Date	28 th April 2025	Issued version	1.0
Author	Dr Lynsey MacLeary & Dr Eric Gillies, cbec eco-engineering UK Ltd		
Technical & Comm. Reviewer	Kate Comins, cbec eco-engineering UK Ltd		
To	Moya MacDonald, Cairngorms National Park Authority		
Project	Dee Valley Restoration		
Subject	DRAFT - Summary of additional modelling work undertaken at construction phase to support planning and permitting requirements

2. DESIGN UPDATES

Figure 2.1. Detailed Design

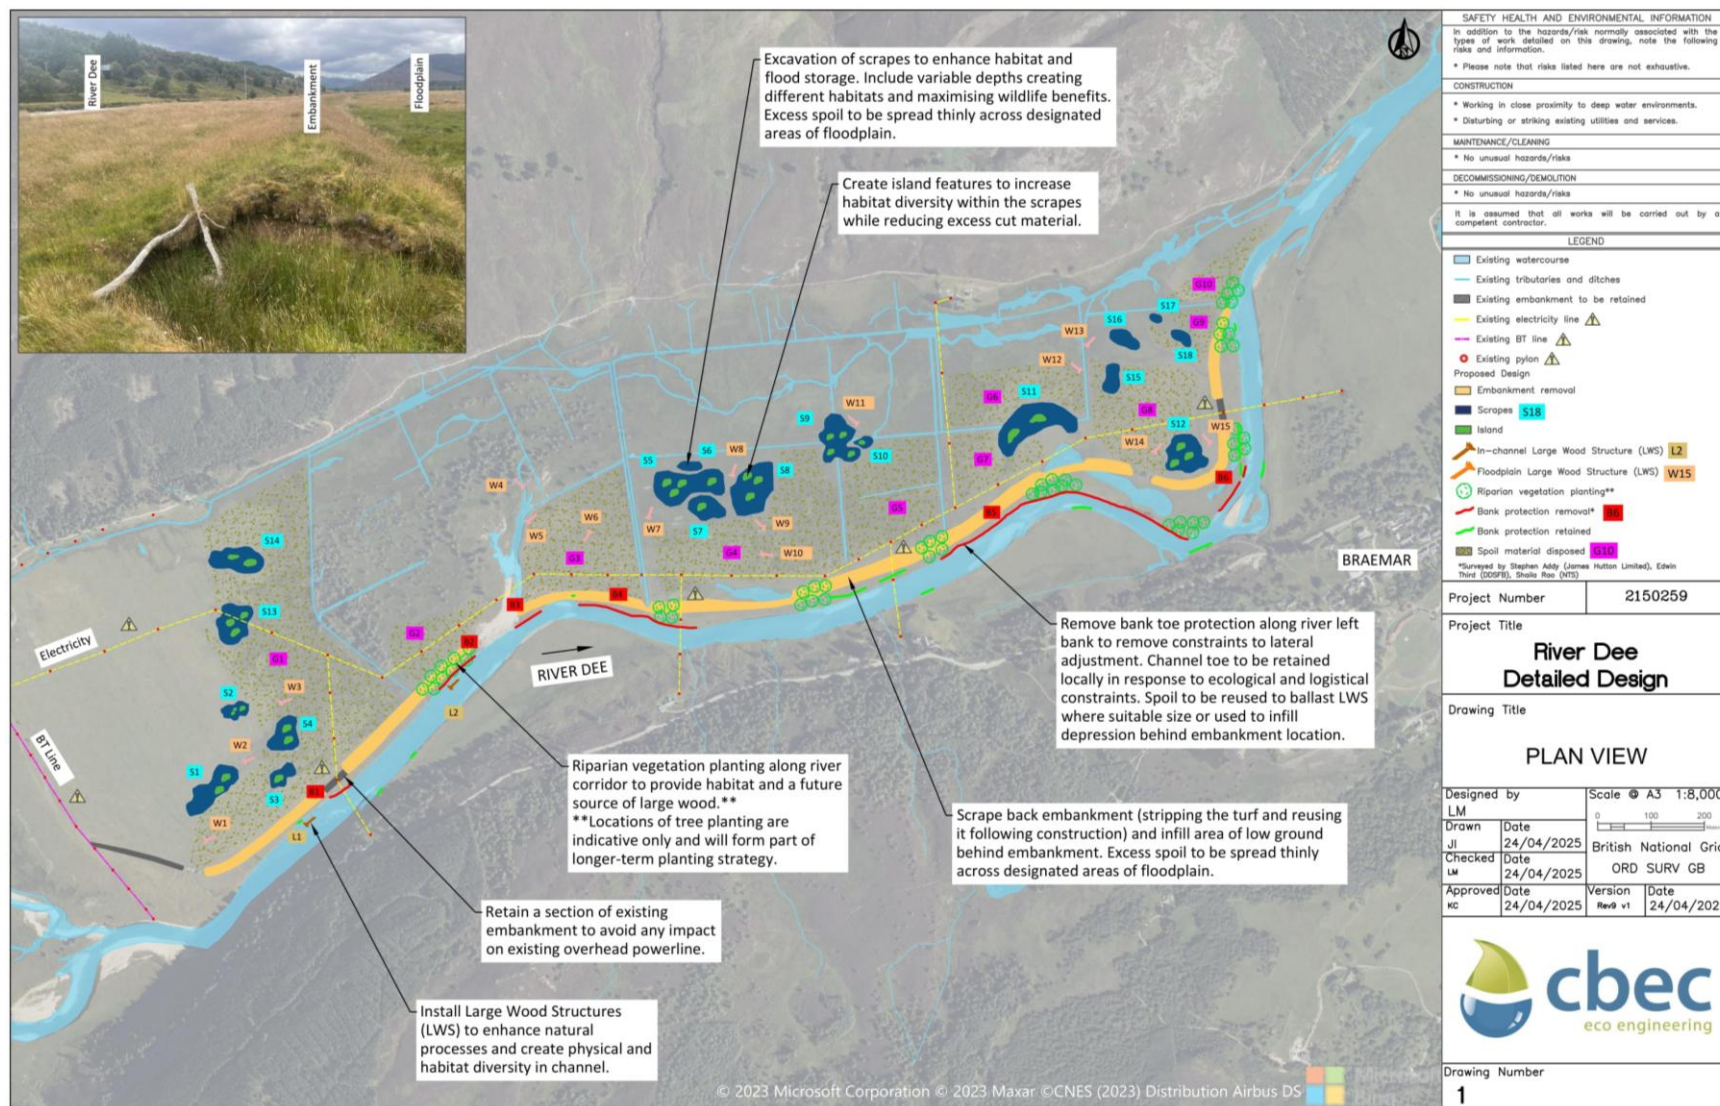
- **Additional wetland scrapes.** Following feedback from the local community amid concerns about flood risk downstream, more wetland scrapes have been added to the design surface with the aim of increasing flood storage. These additional scrapes have been incorporated into the newly modelled design surface through adjustment of the surface in CAD to result in shallow floodplain scrapes with variable topography.

- **Redistribution of spoil.** Cut material will be generated primarily through the removal of the embankment and the excavation of floodplain scrapes, with additional rock generated from the removal of historical bank toe armour. This material is to be disposed of by redistributing it across the site in three ways: (i) infilling the topographic low behind the existing embankment (primarily material from bank toe armour and embankment); (ii) reuse of suitably sized boulders to ballast large wood structures; and (iii) spreading material over designated areas of the floodplain to a depth of ~5 cm. These changes have been implemented through modification of the design surface in CAD.

- **Hard bank protection removal.** Following ongoing engagement with the landowner and the wider project team, some sections of historical bank toe protection are now being retained in response to ecological or logistical constraints. Bank toe armour removal has not been modelled directly because it is not represented by a topographic change within model resolution; additionally, loss of toe armour has only a minor effect on toe friction and affects primarily the evolution of the channel rather than its hydraulic capacity, water levels and velocities. However, to ensure a conservative approach to assessment of flood risk, approximate volumes of rock to be removed have been calculated and these volumes included in the redistribution of spoil across the site. It is assumed that the rock removed will be (i) reused as ballast for the large wood structures where of appropriate size and (ii) redistributed in the deeper parts of the site (primarily behind the existing embankment) and covered by finer spoil material.

- **Large wood structures.** Large wood was represented in the model as a change to the mesh topography (i.e. an increase in height) and an increase in local friction. Following liaison with the landowners, the majority of the in-channel large wood structures have been descope, with only two in-channel structures remaining. All of the original floodplain large wood structures are retained in the design.

Design drawings reflecting the updated design can be seen in Figure 2.1 and appendix A.

Figure 3.1. Hydraulic model results for existing and design conditions – 2yr return period

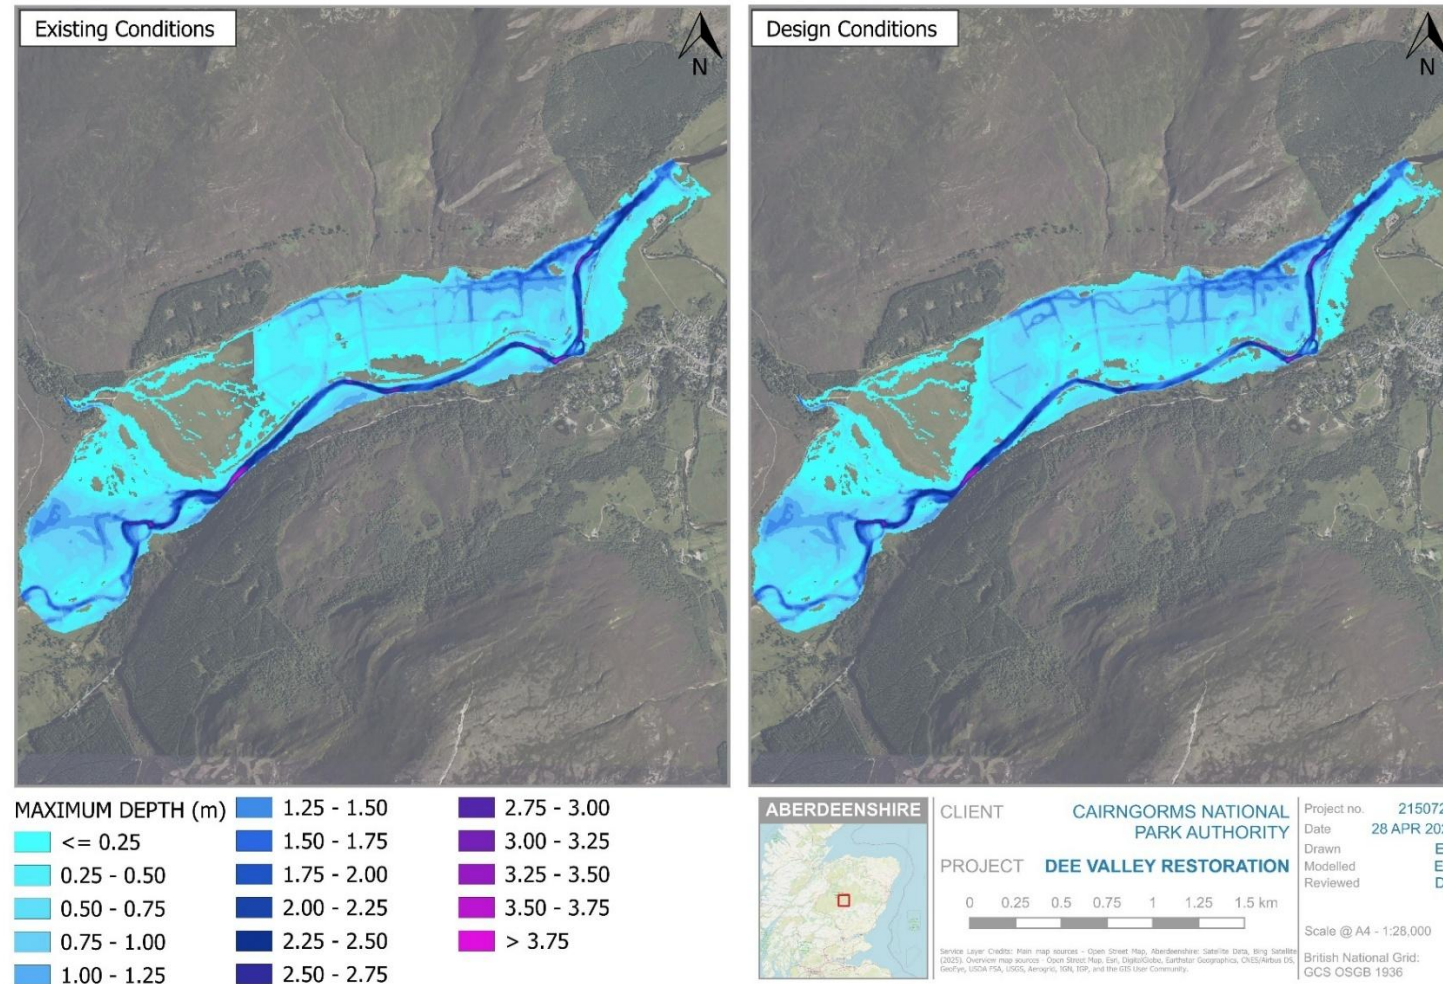
Model results show that the updated design model incorporating additional scrapes and redistribution of spoil on the floodplain has not resulted in any significant changes to the inundation extents and depths and the model results for the updated design surface are aligned with the results for proposed design of 2023 with any changes being within model tolerances.
